Re: Response to Division Letter and Comments of July 26, 2006, Submittal of Reclamation Cost Estimate, and Submittal of Substitute Text Pages, Brush Resources, Inc., Topaz Mine, Juab County, Utah; M/023/003

Appendix 6

Slopes of Existing Open Pit Highwalls

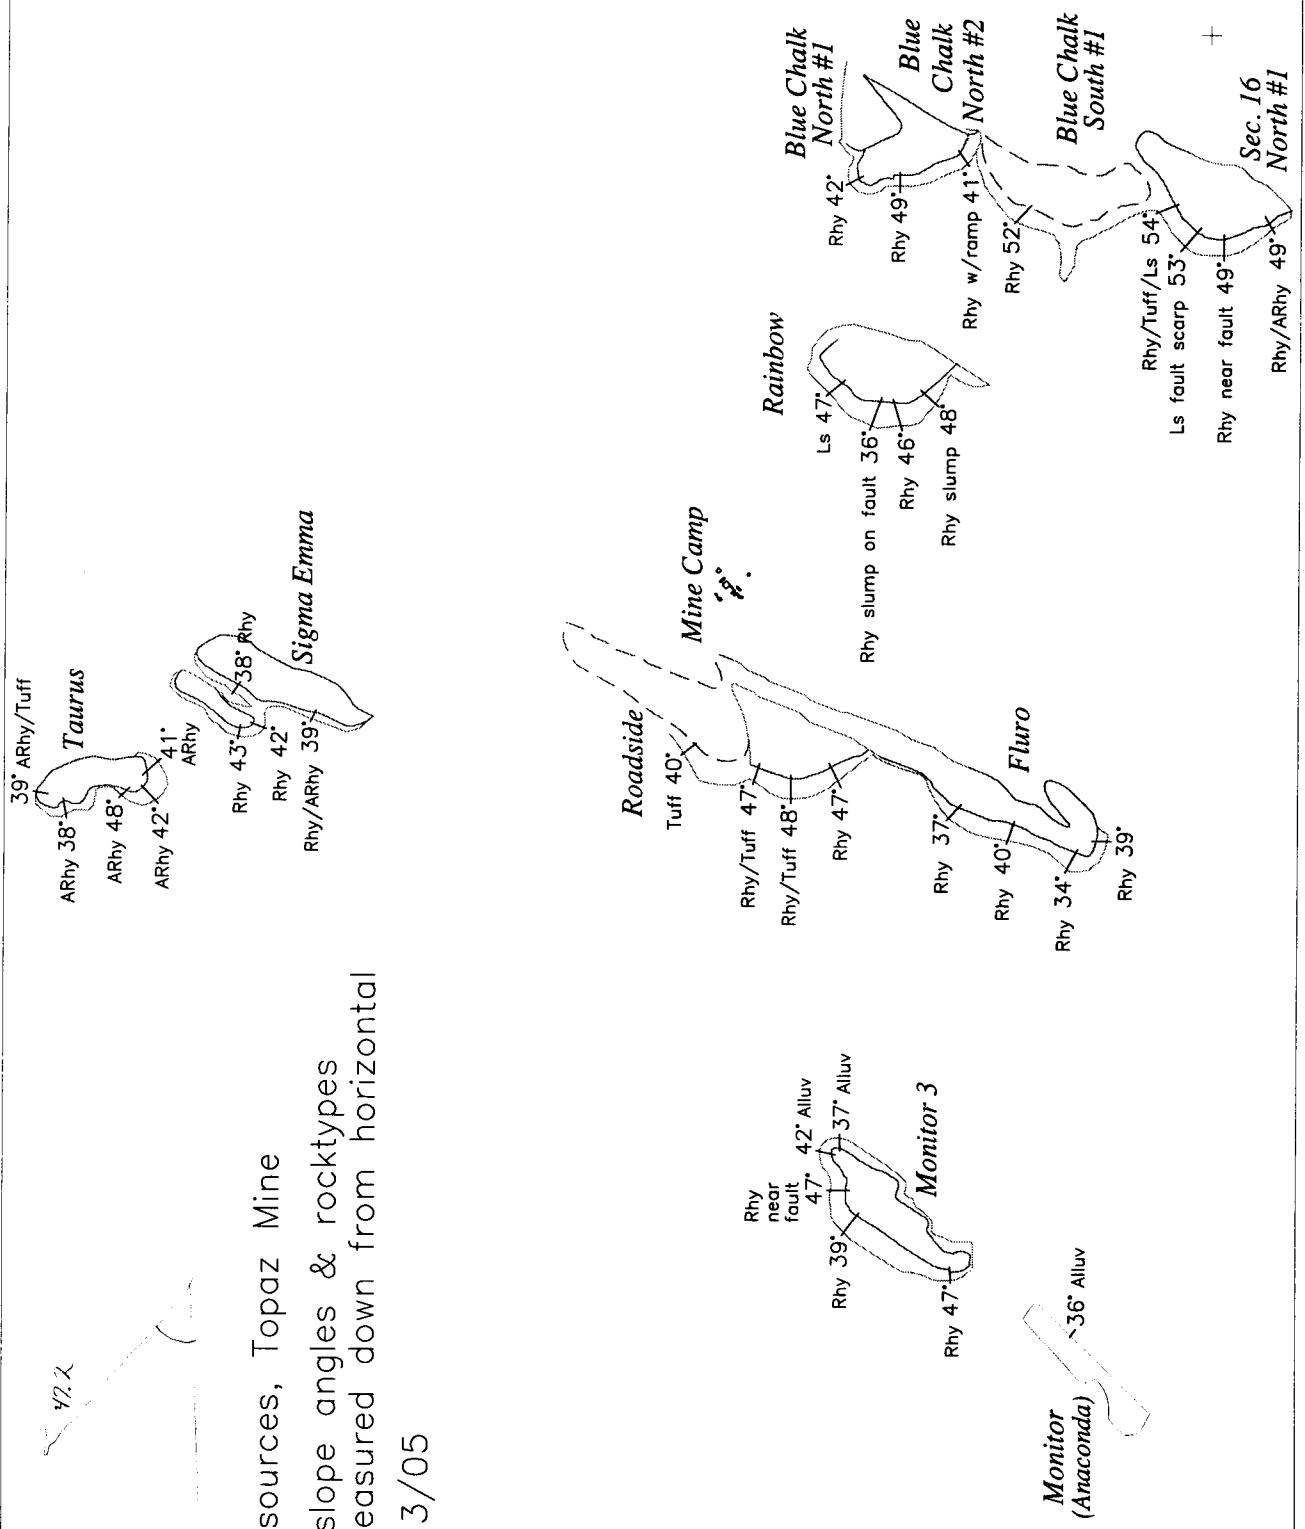
The slopes for existing pit highwalls are summarized on a table and map in Appendix 6.

These data show that of eight existing open pits, four have slopes of 45 degrees or less and the other four have average highwall slopes ranging from 47 to 53 degrees.
